Radiation Safety Implications  
of the Proposed Main Ring/Energy Doubler Abort

J. D. Cossairt

September 10, 1979

This is a review of the radiation safety implications of the Main Ring/Energy Doubler abort dump as proposed by T. E. Toohig on September 7, 1979. Particular emphasis in the review is placed on the inclusion of uranium metal in the dump.

Figure 1

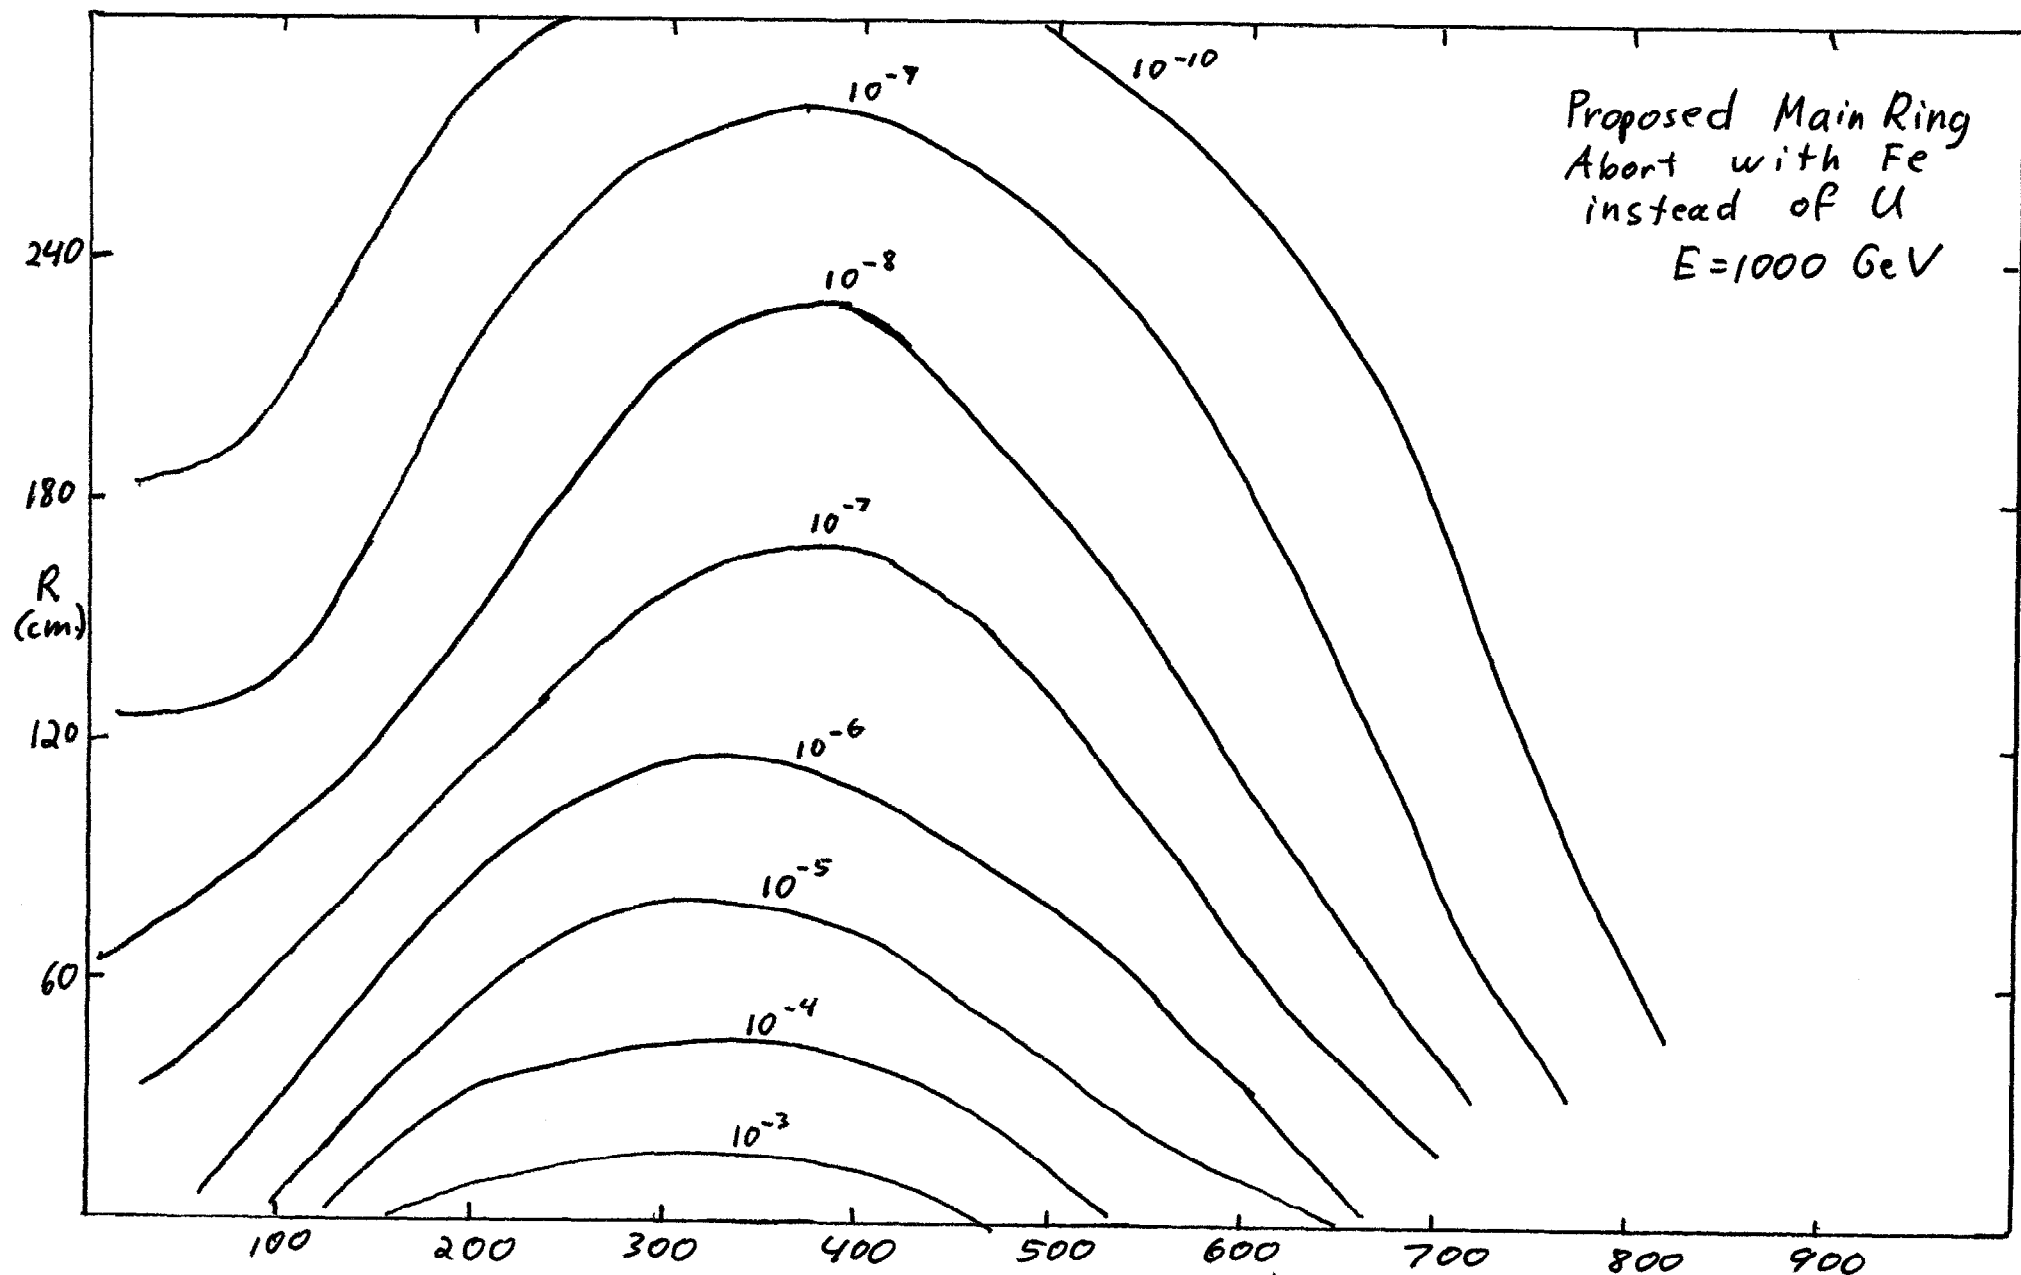
The code CASIM<sup>1</sup> was used to calculate the internuclear cascade in such a dump in order to determine various quantities of interest. For these calculations, 3 forms of the abort were used; one of which specified the geometry of the problem approximately as it has been proposed while the other 2 replaced the uranium with the same volume of iron and lead. In all cases, the calculation was run for an incident beam energy of 1000 GeV. The abort was assumed to be a single dump instead of a combination of 2 dumps. The geometry used as input to the code is shown in Fig. 1. I also assume that  $1 \times 10^{18}$  protons per year will be incident on

Figure 3

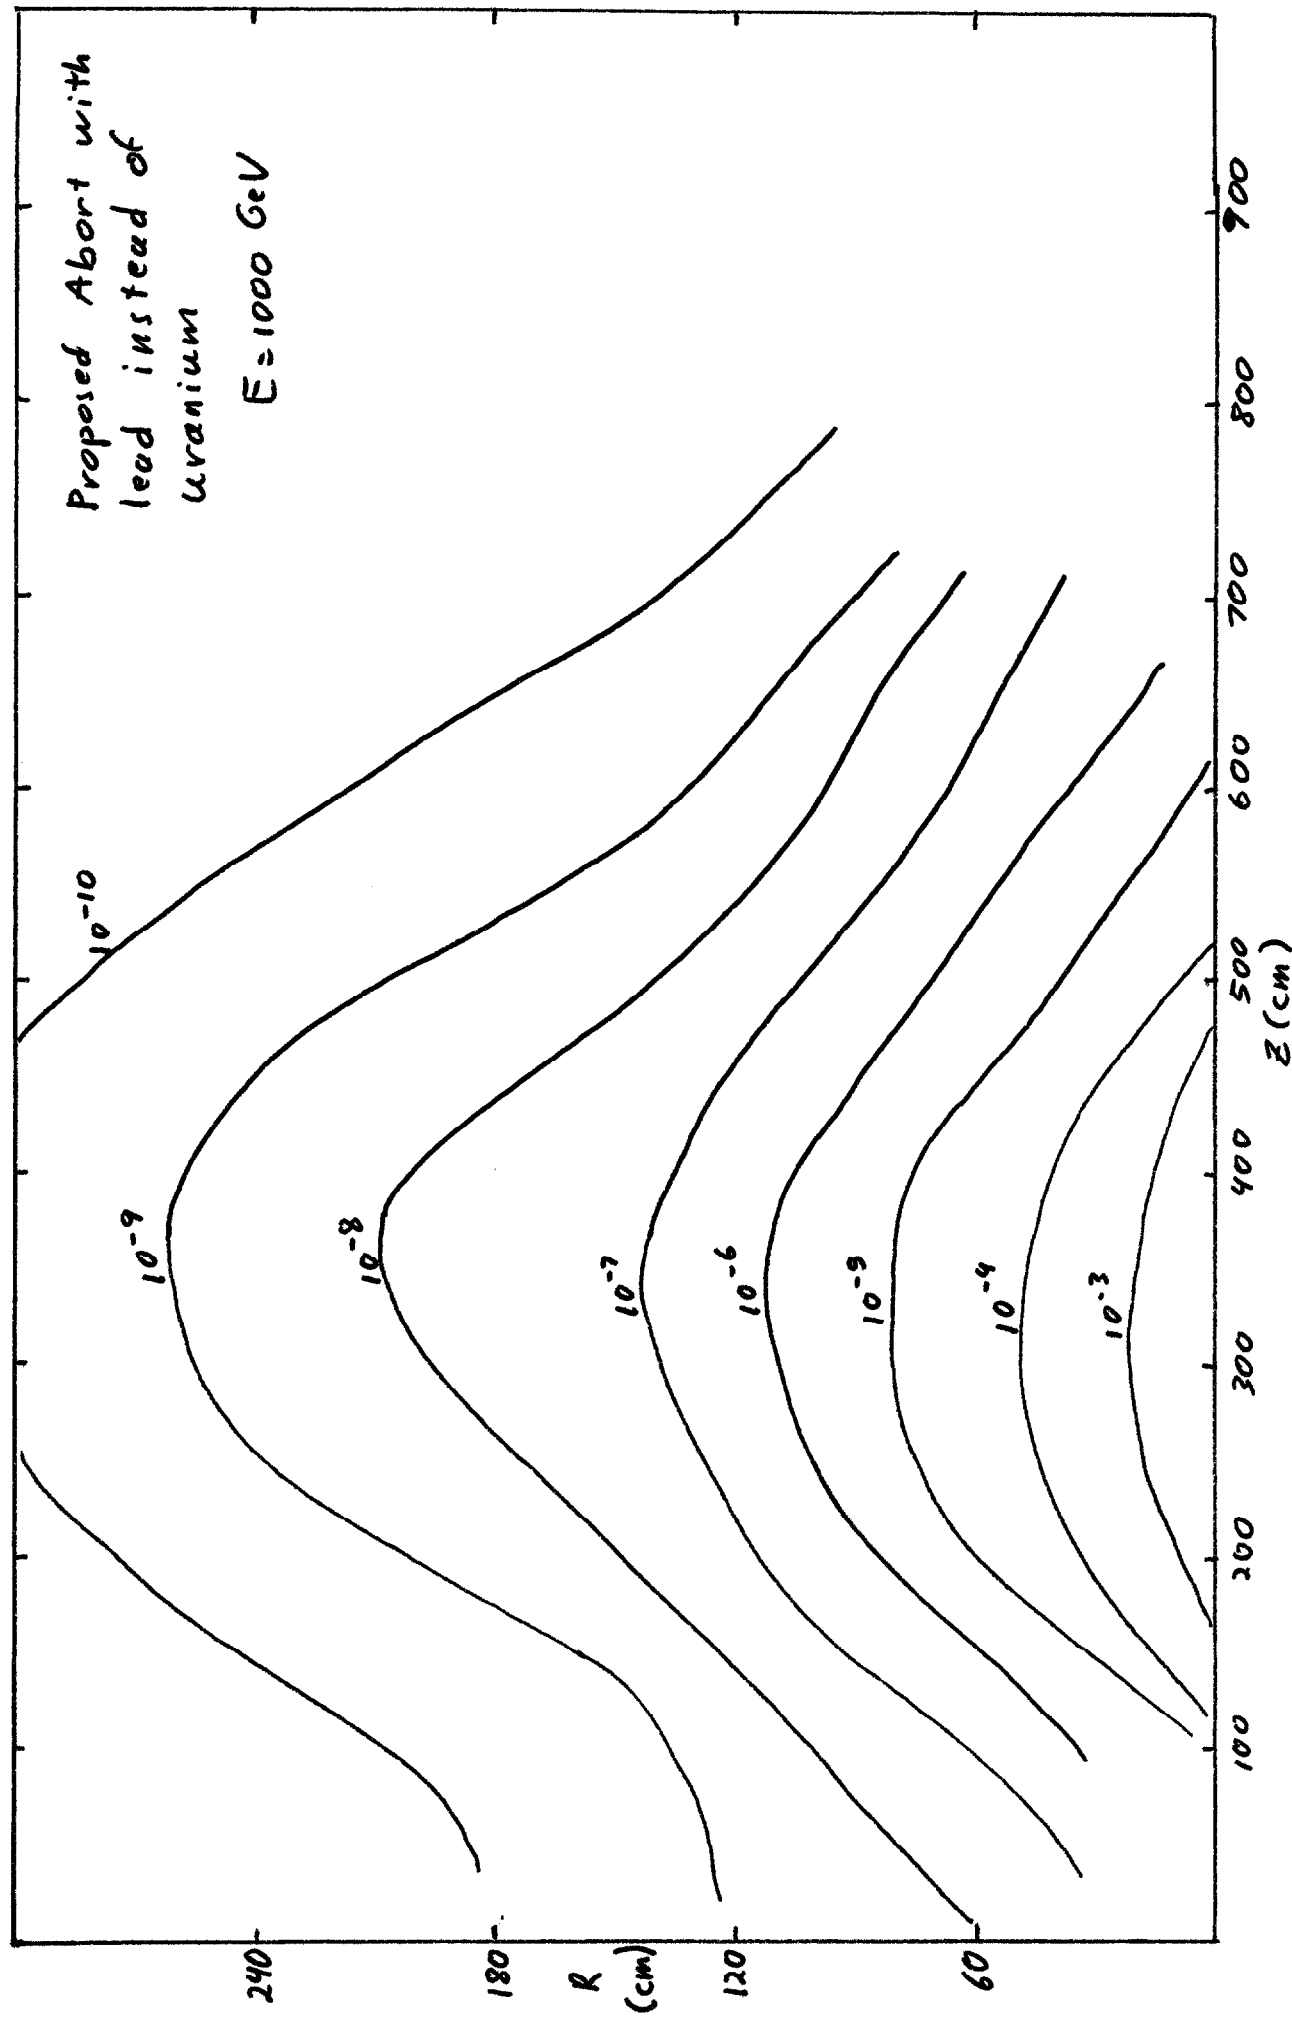
the abort. Perhaps a more realistic estimate is that  $3.5 \times 10^{17}$  protons per year would be aborted.<sup>2</sup> The principal results of the calculations are displayed in Fig. 2, 3, and 4.

If the dump is at the main ring level, el 725.5', a reasonable berm top elevation is 747' or at a radius of 655 cm. Extrapolating from the worst place at R=300 cm using the known attenuation length of soil, the star density in the worst place on top of such a berm is:

$$SD_{\max}(\text{Fe}) = 2.3 \times 10^{-13} \text{ stars}/(\text{cm}^3 \cdot \text{proton})$$

$$SD_{\max}(\text{Pb}) = 2.3 \times 10^{-13} \text{ stars}/(\text{cm}^3 \cdot \text{proton})$$

$$SD_{\max}(\text{U}) = 1.5 \times 10^{-13} \text{ stars}/(\text{cm}^3 \cdot \text{proton})$$

The above numbers are equal when the probable error in the calculation is taken into account. One should be aware that standard CASIM underestimates the star density in a material with large atomic number such as  $^{208}\text{Pb}$  or  $^{238}\text{U}$ .<sup>3</sup> The  $SD_{\max}(\text{Fe})$  implies that at  $5 \times 10^{13}$  protons/pulse, 20 sec. cycle time, a dose rate of 19 mrem/hour would be measured on top of such a berm over the dump. The C0 location is about 5500' from Butterfield Road and the top of the berm is already 22 feet from the source point so that the dose on Butterfield is 0.03 mrem/year at  $1 \times 10^{18}$  protons/year. This is quite low compared with the Laboratory's limit of 10 mrem/year for any off-site location.

Figure 5

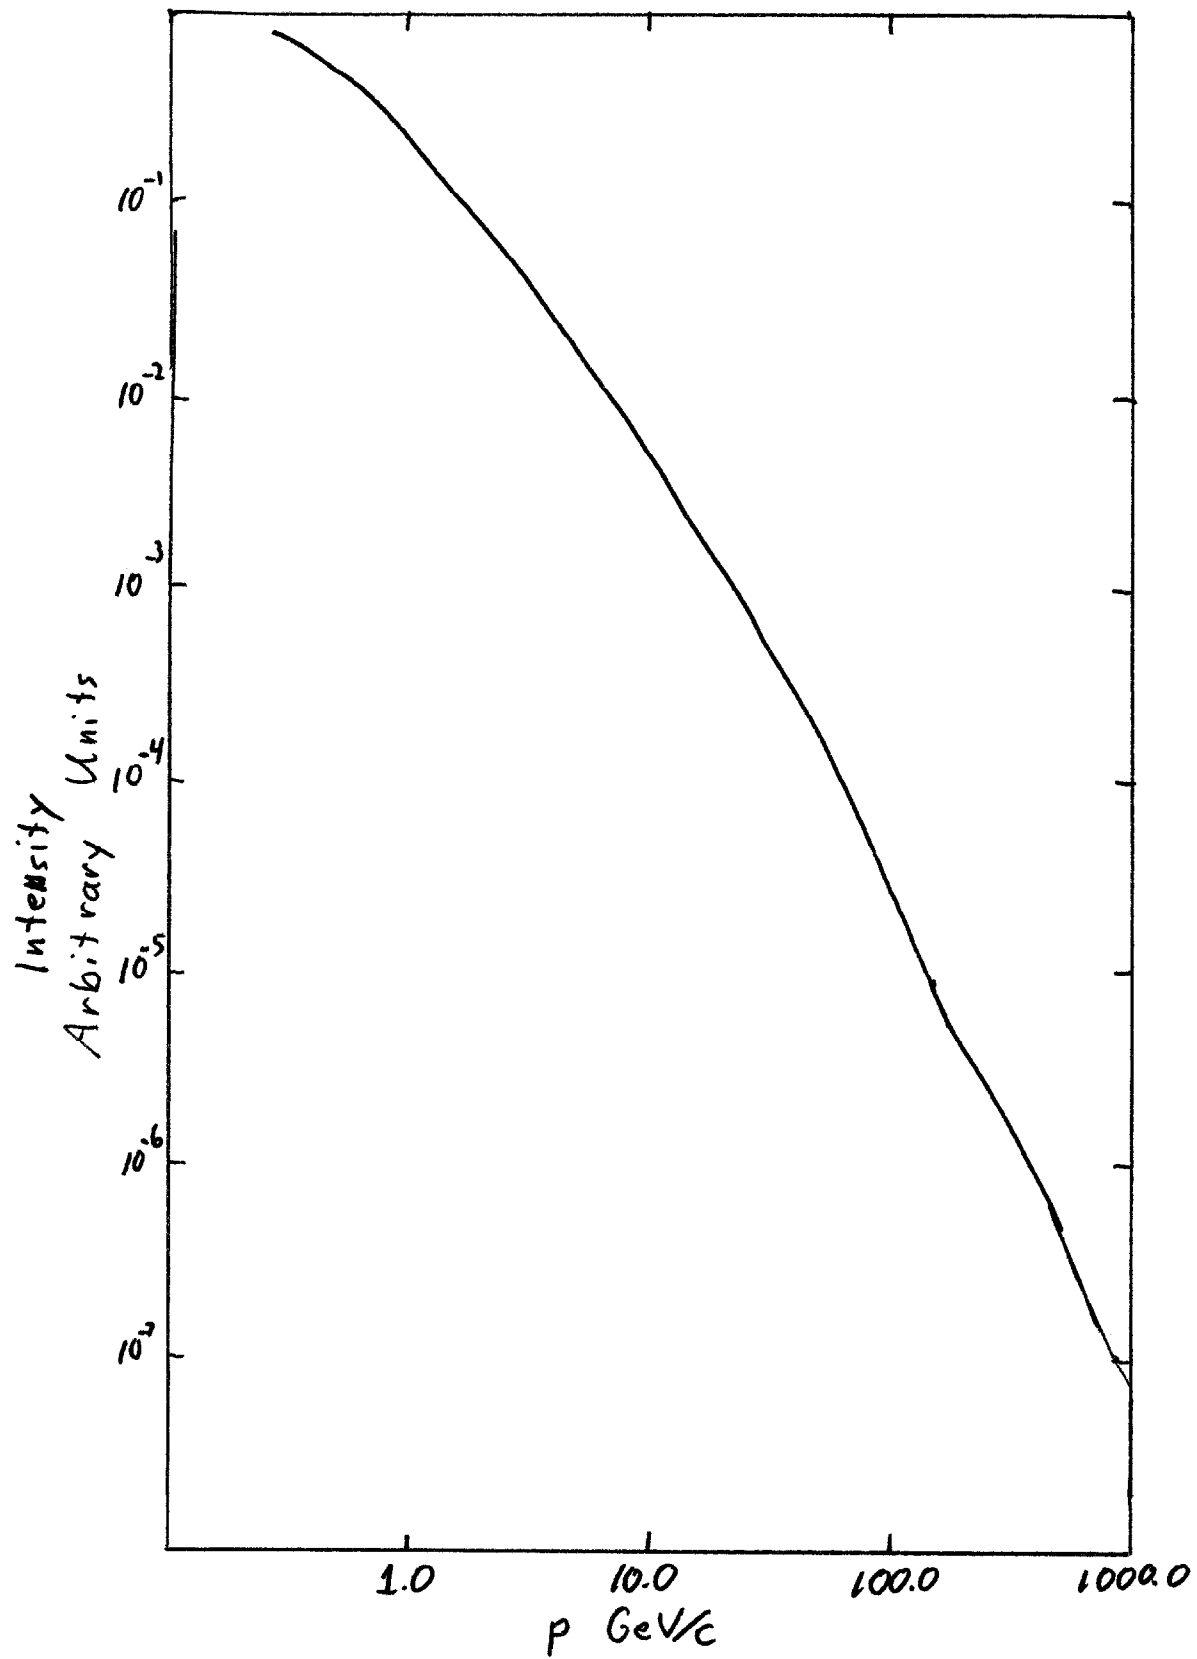
The amount of  $^{239}\text{Pu}$  produced was estimated crudely using the results of a study of the possibility of energy production using accelerators by R. R. Wilson.<sup>8</sup> The spectrum of hadrons incident on the upstream end of the U is shown in Fig. 5 and has an average momentum of 3.3 GeV/c and a flux of  $8.8 \times 10^{-3}$  hadrons/cm<sup>2</sup>·proton) or a total beam of about 16 hadrons/ (incident proton). Scaling the results of FN-298 to the lower momentum, one obtains about 1 gm/year of Pu which, if all taken to be  $^{239}\text{Pu}$ , represents an activity of 0.07 Ci. If other Pu isotopes are present, the activity will be higher because of the shorter half lives.
